## SERVICE BULLETIN SB99.15

**Machines/Models:SB80****Serial Numbers: 1337-1339, 1342-1365,**

**PURPOSE:** Prevent binding of the boom hose and wiring carrier assembly.

Figure 1

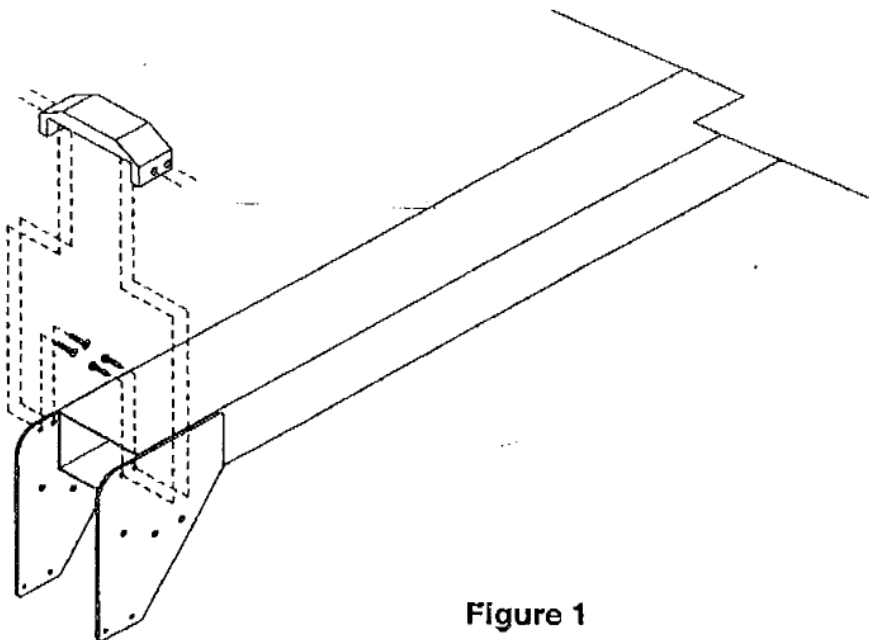
**OPERATION REQUIRED:** Replace rear carrier guide.

1. Remove the carrier track cover.
2. Replace the carrier track rear guide per the following instructions and drawing.
3. Remove the Four screws that hold the rear carrier guide in place (retain hardware).
4. Remove the rear carrier guide.
5. Install the kit supplied carrier guide.
6. Install the carrier guide retaining screws that were removed in step 1.
